Access Compliance Report

Public Rights-of-Way

Intersection ID: 10028420	Main Street: HIGHGROVE_ST	Cross Street: N/A	Location: NE
ADA ID: F57ED1879CF5	Ramp Type: Perp	Initial Pass/Fail: Fail	Overall Compliance: No
Codes/Mitigation Info/Possible Solution		Field Measurements/Component Compliance	
Severity Score: 50

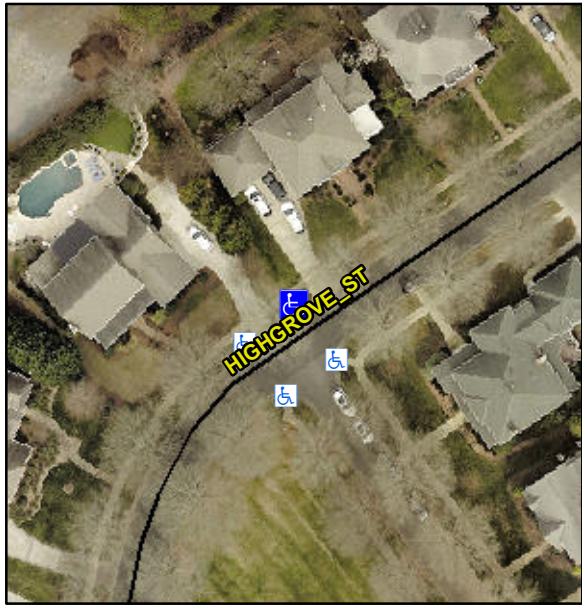
Possible Solutions:	
	Remove & Replace Entire Ramp.	
	Surveyor Notes:	
	N/A	
	PROW/ADA:	
	Not Found, R304.2.2, R304.5.3	
	Total Cost: \$ 1850.00

Compliance	Description	Data	Compliance	Description	Data
N/A	Ramp Length (in)	95.0	No	Ramp Slope (%)	12.2
Yes	Ramp Width (in)	54.0	No	Ramp XSlope (%)	7.9
N/A	Flare Type LT	N/A	N/A	Flare Type RT	N/A
N/A	Flare Slope LT (%)	N/A	N/A	Flare Slope RT (%)	N/A
N/A	Flare Traversable LT?	N/A	N/A	Flare Traversable RT?	N/A
N/A	Landing Length (in)	N/A	N/A	DWS Provided?	N/A
N/A	Landing Width (in)	N/A	N/A	DWS Contrast?	N/A
N/A	Landing Slope (%)	N/A	N/A	DWS Length (in)	N/A
N/A	Landing X Slope (%)	N/A	N/A	DWS Full Width?	N/A
N/A	Landing Curb? (Y/N)	N/A	N/A	DWS Offset (in)	N/A
N/A	Shared Landing?	N/A			
N/A	Gutter Ponding?	N/A	N/A	Gutter Slope (%)	N/A
N/A	Gutter Lip Ht (in)	N/A	N/A	Gutter X Slope (%)	N/A
N/A	Painted X Walk1?	No	N/A	Painted X Walk2?	N/A
	X Walk 1 Direction	To SE		X Walk 2 Direction	N/A
N/A	X Walk 1 Width (in)	N/A	N/A	X Walk 2 Width (in)	N/A
	X Walk 1 Slope (%)	3.4		X Walk 2 Slope (%)	N/A
	X Walk 1 X Slope (%)	5.1		X Walk 2 X Slope (%)	N/A
